STATE OF WASHINGTON
DEPARTMENT OF ECOLOGY

Re: NFA Likely Opinion for Proposed Cleanup of the following Site:

Site Name: Luther Burbank Park
Site Address: 2040 84th Ave SE, Mercer Island, King County, WA 98040
Facility/Site ID: 74911249
Cleanup Site ID: 4749
VCP Project ID: XN0067

Figure 7

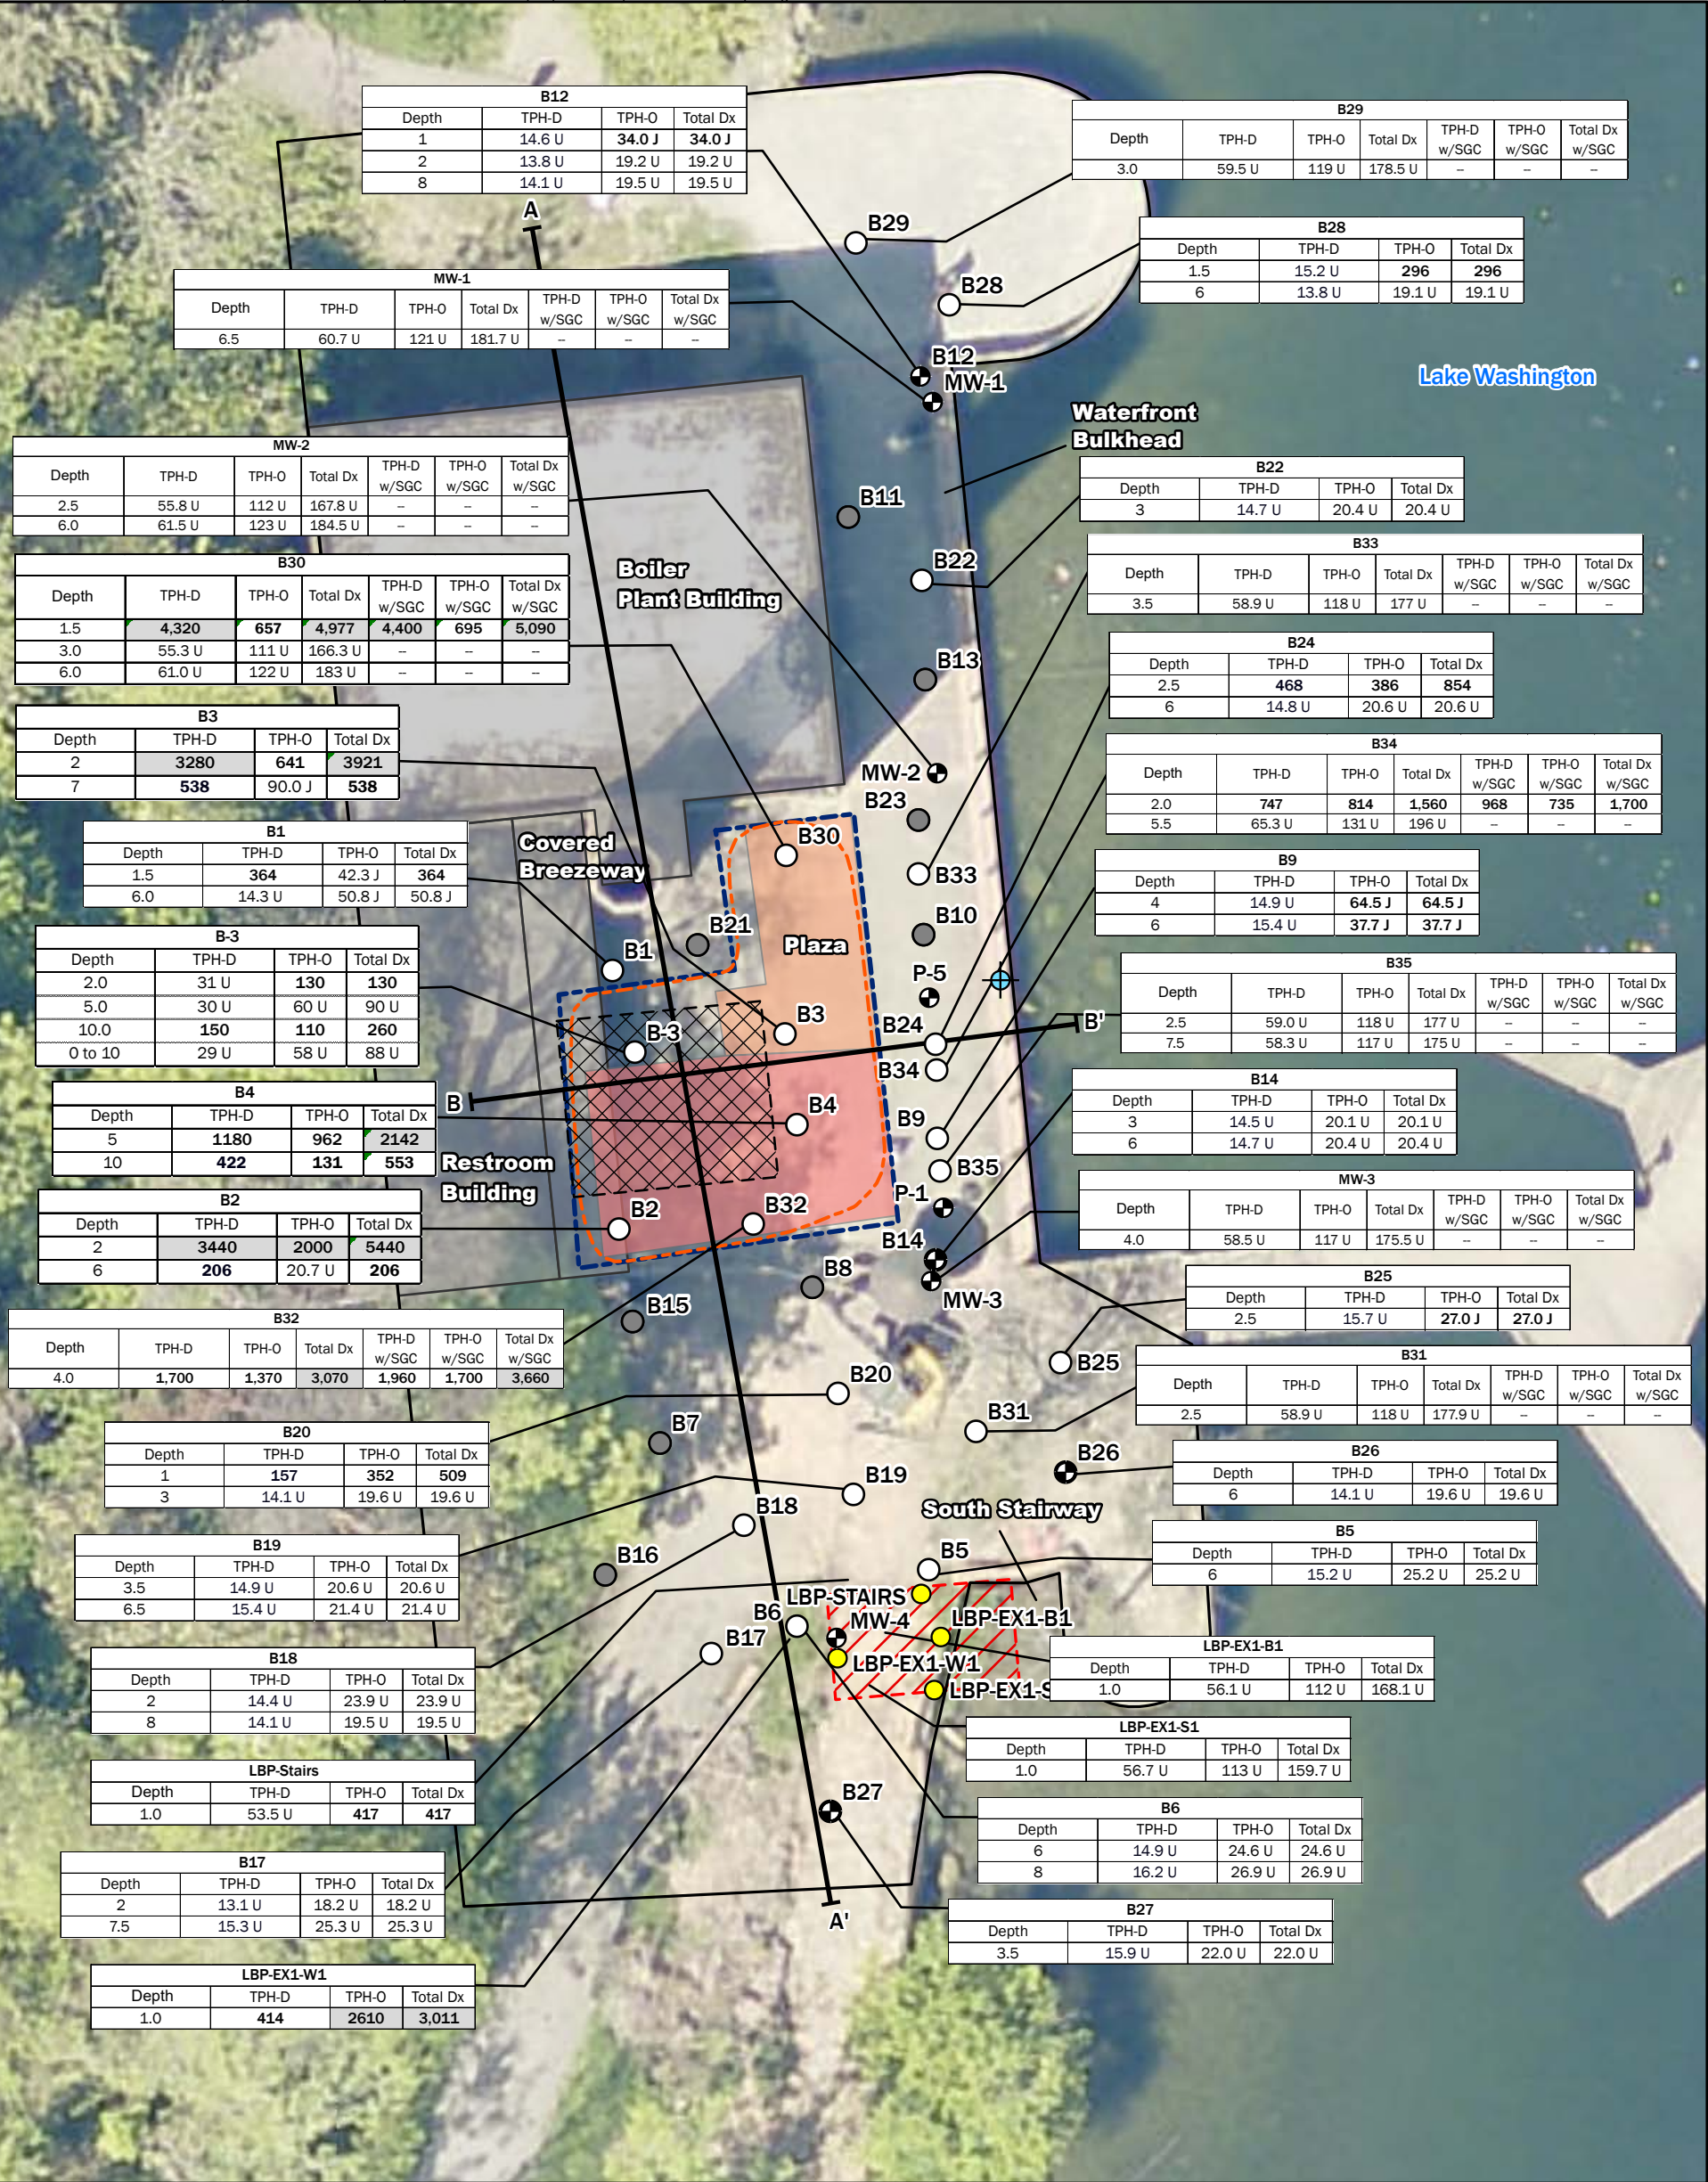
The 2002 cleanup level exceedances were removed via excavation in 2002 and Ecology issued an NFA letter in 2003. Additional soil characterization was conducted between 2022 and 2025, and contamination above cleanup levels was discovered in 2023. As can be seen from the results in Table 1, the soil contamination found in 2022-2025 was of lower magnitude than the previously found contamination. The maximum depth of this contamination was 5 ft bgs at location B4 (see Figure 7 in Appendix A).
